November 7, 1991

VOGTLE ELECTRIC GENERATING PLANT  
REQUEST TO REVISE TECHNICAL SPECIFICATIONS  
3/4.6.1.7 AND 4.6.1.2f

## ENCLOSURE 1

#### BASIS FOR PROPOSED CHANGE

FIGURE 1

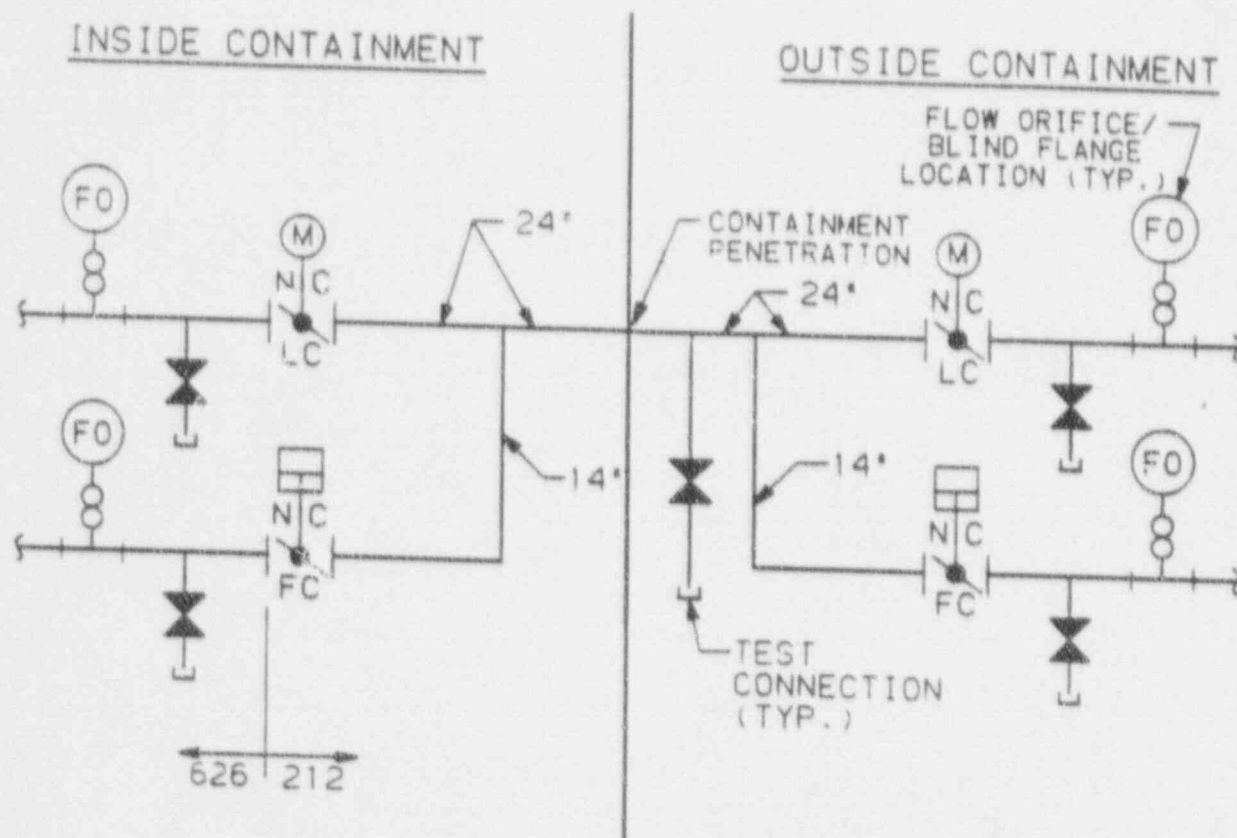
Section III.C, "Type C Tests," of Appendix J, "Primary Reactor Containment Leakage Testing for Water-Cooled Power Reactors," to 10 CFR 50 states that for containment isolation valve local leak rate testing, "pressure shall be applied in the same direction as that when the valve would be required to perform its safety function, unless it can be determined that the results from the tests for a pressure applied in a different direction will provide equivalent or more conservative results." As a result of Information Notice No. 88-73, it is uncertain that the preferred method of testing at VEGP can be considered to provide equivalent or more conservative results with respect to the inboard containment purge supply and exhaust isolation valves. However, in order to test these valves by pressurizing in the accident direction, containment entry is required. Since these tests must be performed at quarterly intervals as required by existing surveillance requirement 4.6.1.7.2, the necessity of making a containment entry each time the test must be performed works a hardship on plant personnel, especially from the standpoint of maintaining personnel exposure as low as reasonably achievable (ALARA). Figure 1 illustrates the typical arrangement of valves, test connections, and blind flanges for purge supply and exhaust penetrations.

The purpose of these quarterly tests is to identify excessive degradation of the resilient seals. The quarterly test, under the provisions of the proposed amendment, will provide indication of seal degradation by one of two ways as follows:

- o First, the quarterly "between valve" test results will be trended. If the current leakage exceeds the previous leakage by 10 percent of 0.06 La, the "between valve" test frequency will be increased to at least once per month. The value of 10 percent of 0.06 La is conservatively low and yet it is high enough to accommodate normal variation due to periodic cycling of the valves. Increasing the test frequency is an appropriate response to the potential degradation indicated by the increased leakage.
- o If the current "between valve" test results exceed 35 percent of 0.06 La, then a Type C test must be performed within 24 hours. The limit of 35 percent of 0.06 La was chosen as a conservative value based on a comparison of historical leak rate test results for these valves. These test

- o The containment purge supply and/or exhaust penetration leakage must be less than 0.06 La and the combined leakage rate for all penetrations and valves subject to Type B and C tests must be less than 0.60 La.
- o Quarterly "between valve" test results will be trended. If the current leakage exceeds the previous test leakage by 10 percent of 0.06 La, then the "between valve" test frequency will be increased to at least once per month.
- o If the current "between valve" test leakage exceeds 35 percent of 0.06 La, then a Type C test must be performed within 24 hours. The value of 35 percent of 0.06 La is the limit referenced in proposed Technical Specification surveillance requirement 4.6.1.7.3.
